**ADDENDUM NO. 2  
CITY OF BELEN, NEW MEXICO  
SEPTEMBER 24, 2021**

**RE: 2021 COOP Improvements – Sixth Street Reconstruction**

The following Addendum shall be incorporated into the Contract Documents for the above-referenced project.

# EXISTING CONDITIONS / DEMOLITION PLAN

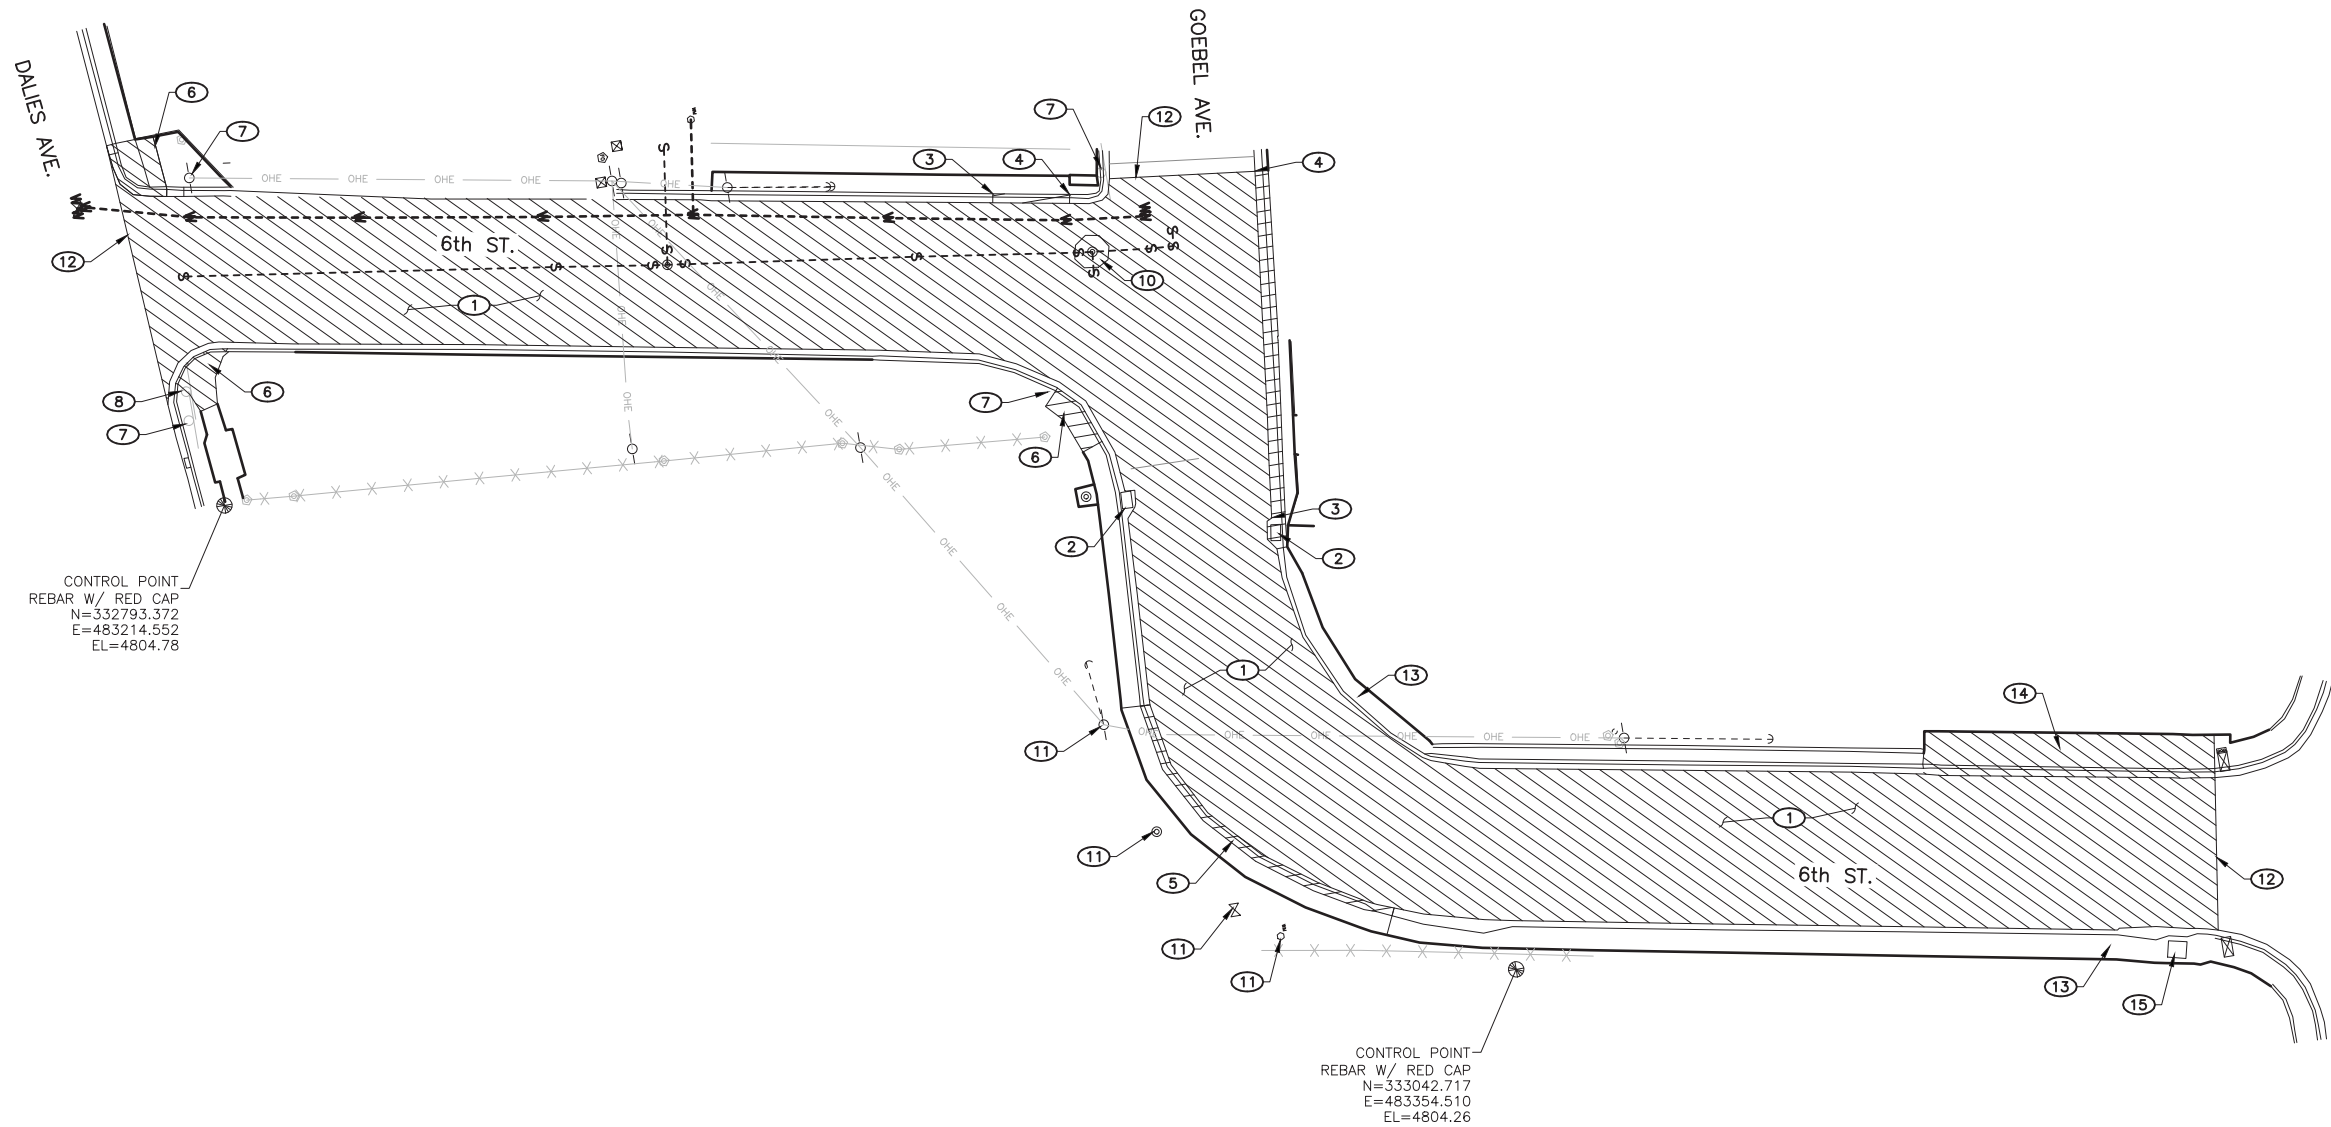
- 1) The removal of base course material shall be incidental to Item No. 1.
    - 2) The drive pad on the west side of 6th Street near the NM 309 intersection is intended to be removed and replaced. The Keyed Notes have been amended to the re-issued Sheets C-101 and C-202 and Item Nos. 6a. and 16a have been added in the Bid Form. Removal and replacement of the curb directly adjacent to the drive pad shall be incidental to these line items.

1. **SHEET C-101, EXISTING CONDITIONS / DEMOLITION PLAN:**
  - a. Remove and replace Sheet C-101 with the revised Sheet C-101, included in this Addendum No. 2.
2. **SHEET C-202, SIXTH STREET PLAN AND PROFILE STA. 13+00.00 TO STA. 15+31.00:**
  - a. Remove and replace Sheet C-202 with the revised Sheet C-202, included in this Addendum No. 2.

- 1 MILL EXISTING ASPHALT PAVEMENT SURFACE
- 2 REMOVE AND REPLACE EXISTING STORM DRAIN INLET
- 3 BEGIN REMOVE AND REPLACE EXISTING CURB AND GUTTER
- 4 END REMOVE AND REPLACE EXISTING CURB AND GUTTER
- 5 REMOVE AND REPLACE EXISTING VALLEY GUTTER
- 6 REMOVE AND REPLACE EXISTING PEDESTRIAN RAMP
- 7 EXISTING SIGN TO REMAIN IN PLACE
- 8 EXISTING SIGN TO BE REMOVED AND RELOCATED
- 9 EXISTING SIGN TO BE REMOVED AND REPLACED
- 10 REMOVE EXISTING CONCRETE COLLAR AROUND SAS MANHOLE
- 11 EXISTING UTILITY TO REMAIN IN PLACE
- 12 SAWCUT NEAT LINE
- 13 EXISTING DRIVEPAD TO REMAIN IN PLACE
- 14 REMOVE AND REPLACE EXISTING DRIVEPAD
- 15 EXISTING STORM DRAIN INLET TO REMAIN IN PLACE
